# **Land South East of Baynards House and Land North West of Baynards House, Ardley**

Consultation Response – Technical Note

*(Planning Applications 21/03267/OUT and 21/03268/OUT)*

DTA Drawing 17213-25a-GA  
Baynards Green Mitigation

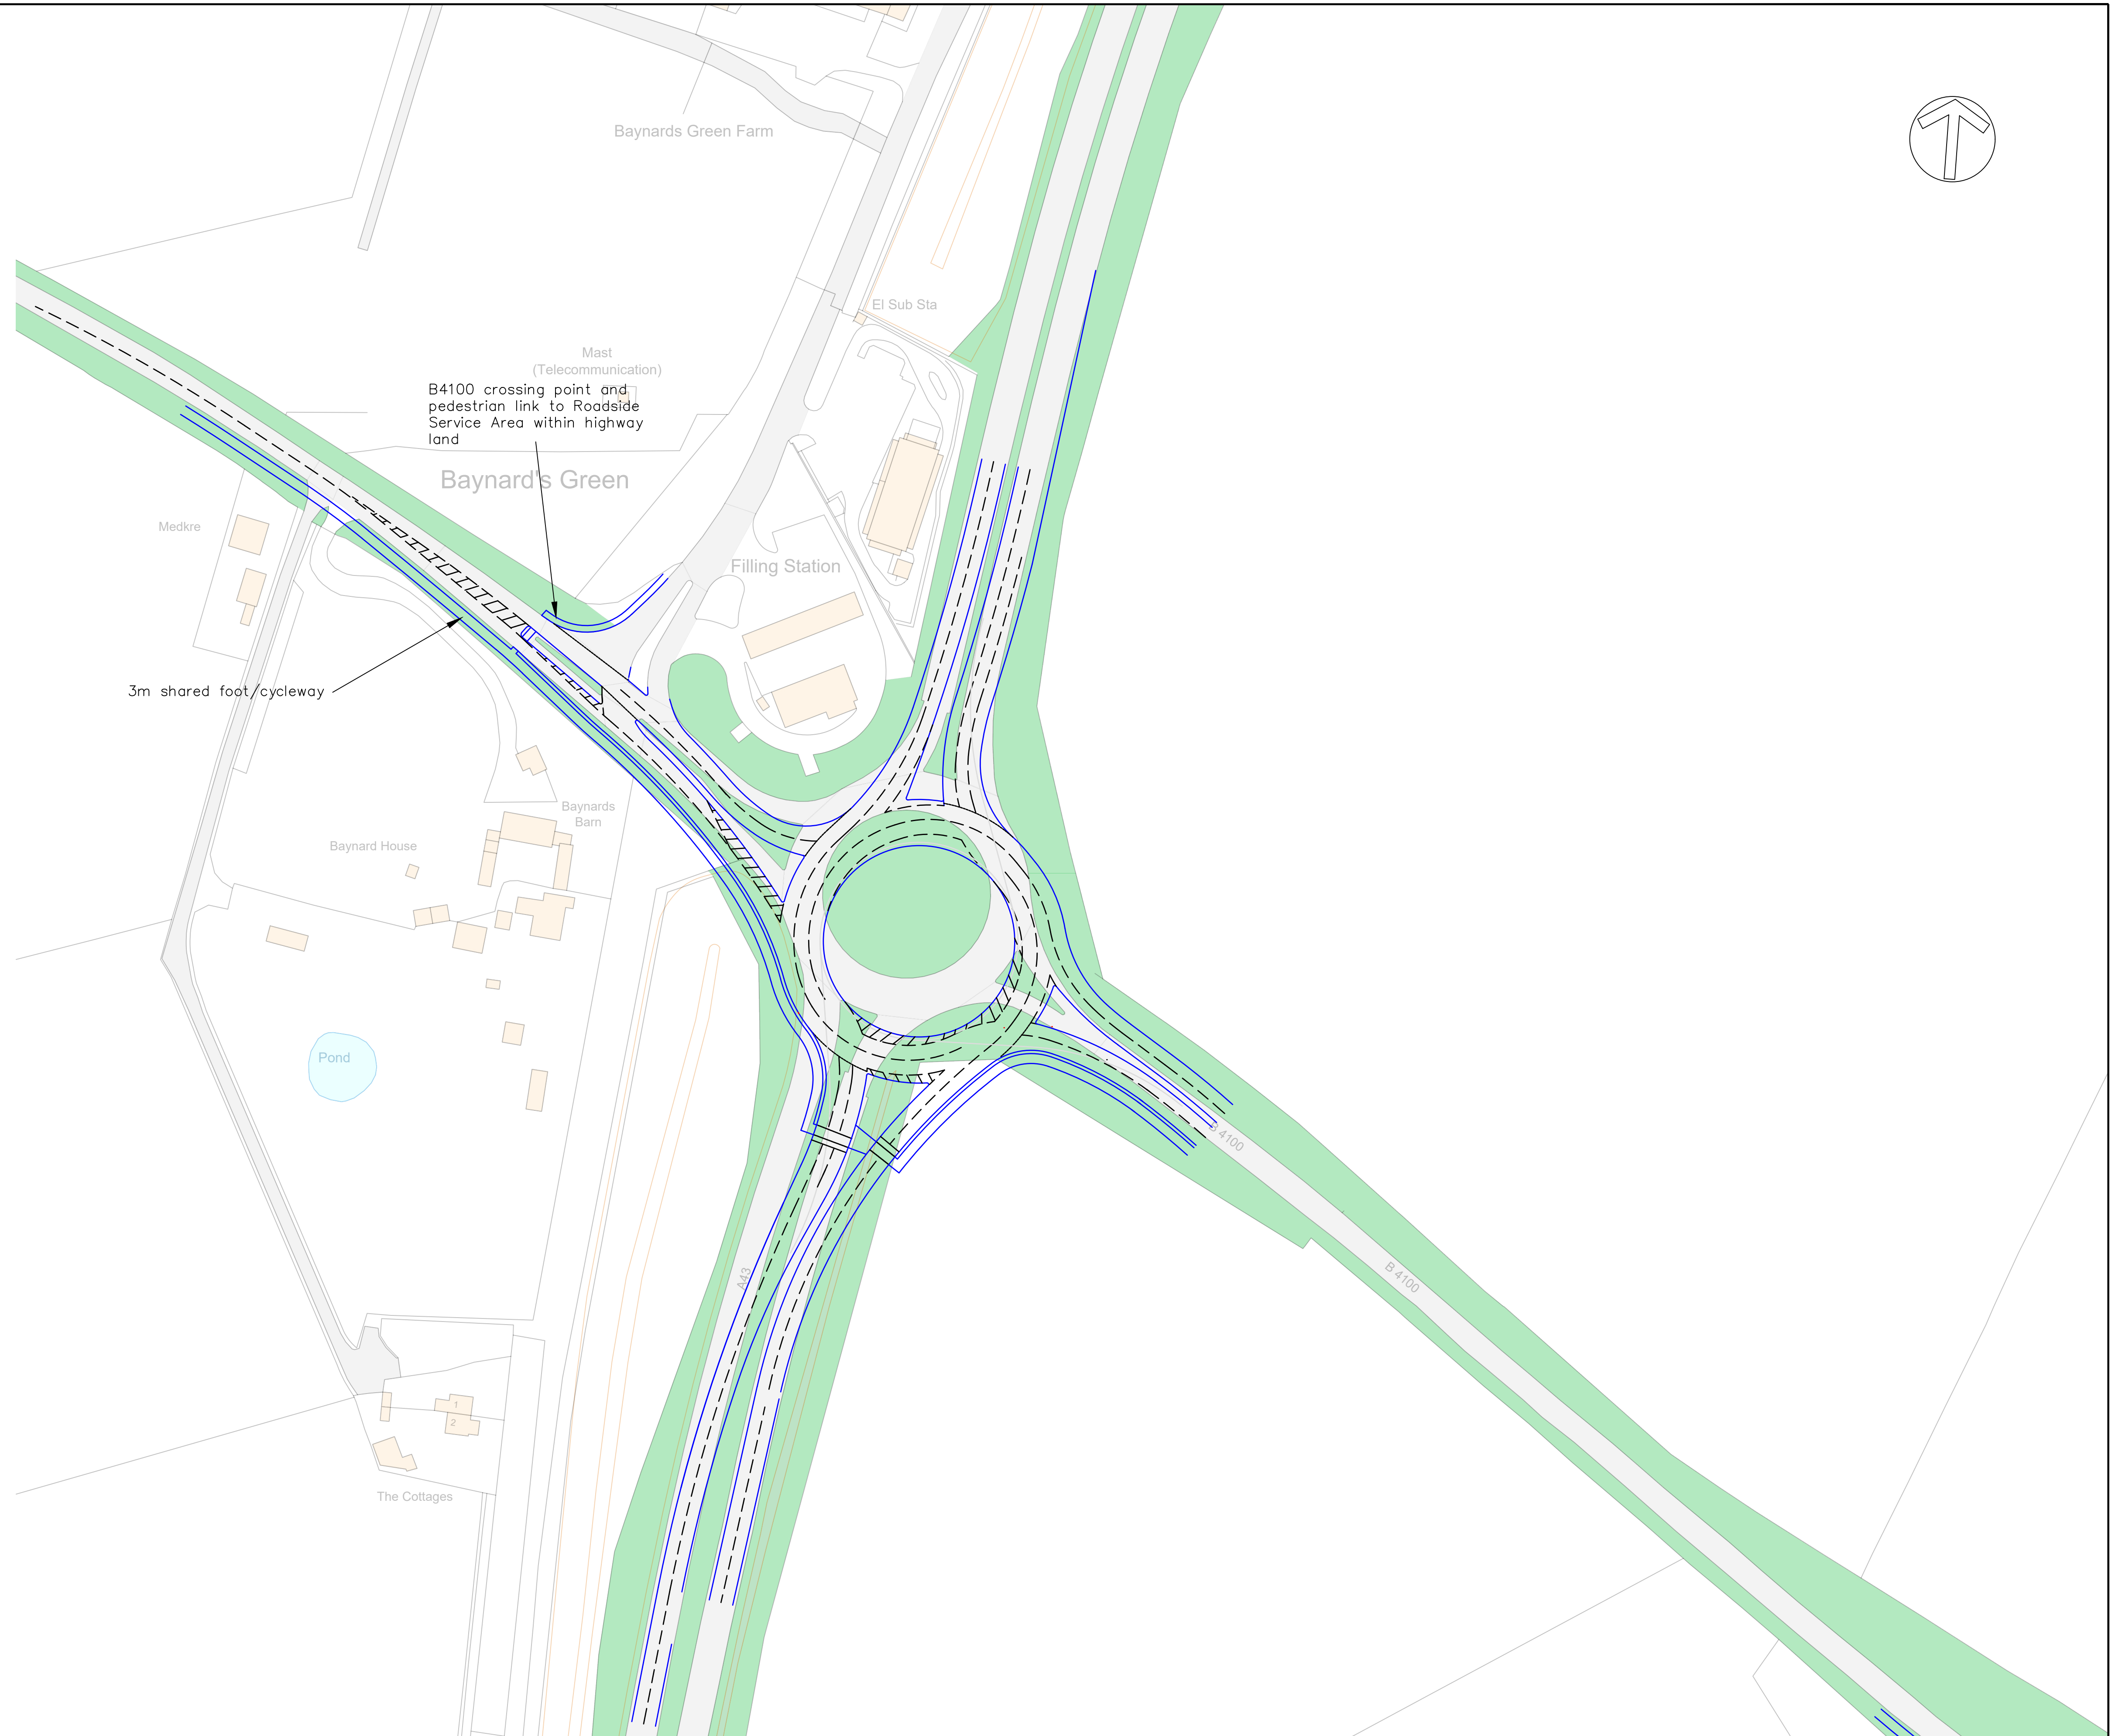
The applicant has proposed an interim mitigation scheme at the A43 Baynards Green roundabout which includes widening of the B4100 entries and a standalone signal-controlled toucan (pedestrian and cycle) crossing.

Given the concerns set out above and the uncertainty of some elements of the Growth Deal, there remain outstanding concerns. National Highways is therefore not yet in a position to comment on the suitability of the interim mitigation scheme.

14. In order to mitigate the impact of the application sites (East + West) traffic, a concept mitigation scheme has been prepared and is shown on **DTA Drawing 17213-25a-GA**. The inscribed circle diameter of the roundabout is increased from 70m to 85m, with additional approach lanes and flaring identified. The proposed junction layout meets with relevant design standards. A signalised pedestrian/cyclist crossing is provided on the A43(S) arm.

16. The appraisal clearly demonstrates that the proposed scheme fully mitigates the impact of the development proposed via both applications (East + West) at the junction. Indeed, the scheme also provides betterment in the sense that the junction is forecast to operate within capacity in 2031, with only modest queues forming. This includes the effect of accommodating committed development traffic as included within the BTM, as agreed with CDC/OCC. The forecast operational level allows significant confidence that any detailed revisions to design detail or traffic flow forecast refinements will not change the conclusion that the proposal mitigates site impact at Baynards Green.
